7417111 Rpl Condensate Pipe SP218 & SP77, Marine Corps Air Station Cherry Point, NC

The purpose of this amendment is to answer pre-proposal inquiries (PPIs)

Subj: AMENDMENT TO WO7417111 , Replace Condensate Pipe SP218 and SP77,MCAS
CHERRY POINT NC

12908484 MECHANICAL DEMOLITION STEAM PIT DETAILS

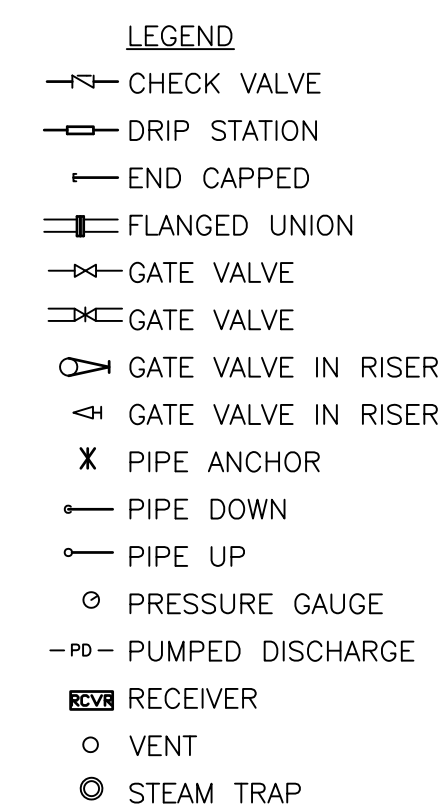
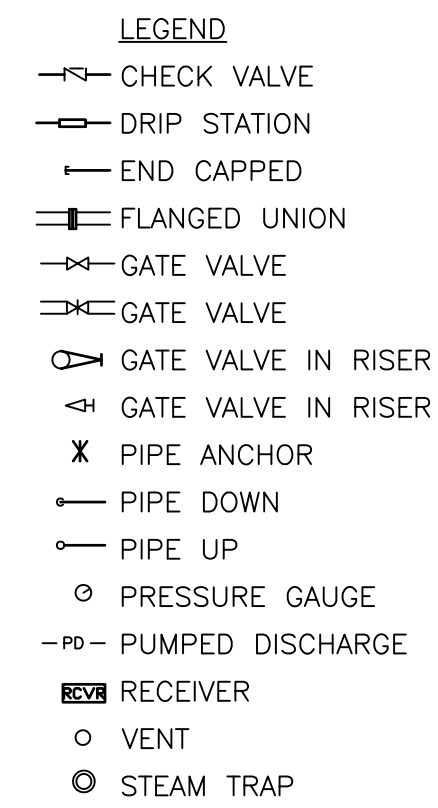
10. Has there been an Asbestos report done on the piping?

- 1 REMOVE PIPING, INSULATION, AND SUPPORTS DISCONNECT FROM FLANGE.
- 2 ASSUME THE MASTIC AT THE PIPE PENETRATIONS INTO THE STEAM PITS CONTAIN ASBESTOS. REFERENCE SPECIFICATION 02 82 16.00 20 FOR PROPER PROCEDURES.

Response: Reference revised NAVFAC drawing 12908484. Reference specification section 02 82 16.00 20.
